IN THE MATTER of proposed Plan Change G: Aokautere Urban
Growth to the Palmerston North City Council
District Plan

**SUPPLEMENTARY STATEMENT OF HARRIET FRASER ON BEHALF OF PALMERSTON NORTH
CITY COUNCIL**

TRANSPORT

Dated: 11 March 2024

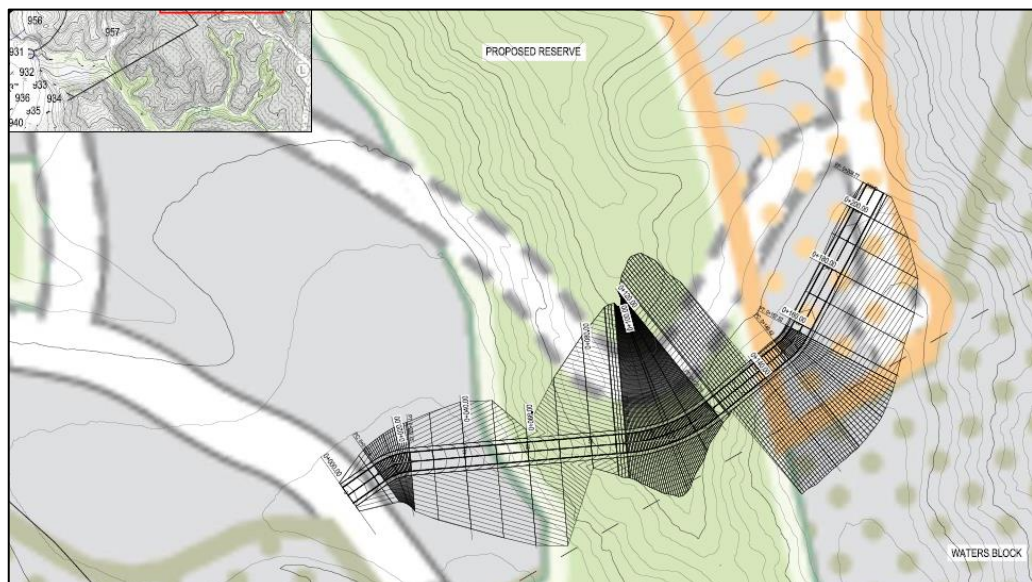
[18] The requested change for the **Terrace Link Road** is shown in Resonant Drawings 212018 Sheets 1 to 5. The extract below shows the alignment sought by PNIRD.

- [19] The proposed alignment achieves a road connection between Valley Views and the plateau. It connects with the proposed local road network in a different location on the plateau. This will require some consequential changes to the road hierarchy. The Terrace Link Road will be a Peri-Urban Road. The east-west connection across the plateau from the Terrace Link Road to the extension to Pacific Drive will need to be a Connector Road.

- [20] The Structure Plan includes a break in the Peri-Urban route between Valley Views and the plateau which will provide for active modes only until the Valley Views intersection with Turitea Road is upgraded. This break should be shown to the north of the likely access location to Lot 912 on the Resonant drawings.

- [21] The long-section shows a gradient of 1 in 80 on the lower section transitioning to a gradient of 1 in 8.2. In my opinion a gradient of up to 1 in 8 in response to minimising earthworks is satisfactory. I note that sections of the road included in the Structure Plan to date are likely to have had a similar grade. During detailed design careful consideration will need to be given to grade transitions, forward sightlines along the road and available sight lines at the intersection at the top of the link.

- [22] The cross-sections show the road having a formed width of around 6m. No provision is shown for a footpath but there is space on the downward side of the road for a footpath to be constructed.

- [24] The drawing information provided by Resonant on behalf of PNIRD also included a new roading link from the extension of Valley Views to Turitea Road. In order to minimise the length of Turitea Road that is exposed to additional traffic activity from rural-residential development (for the reasons discussed at H below), I recommend that traffic from this development accesses Turitea Road via the existing section of Valley Views and the intersection with Turitea Road. As such, I do not support the requested new link onto Turitea Road.

- [23] Subject to the necessary design refinement regarding grade transitions, forward sight lines and the provision of a footpath, as described in paragraphs 21 and 22 above, that can be expected through the resource consent process, I support the requested amendment to the alignment for the Terrace Link Road.
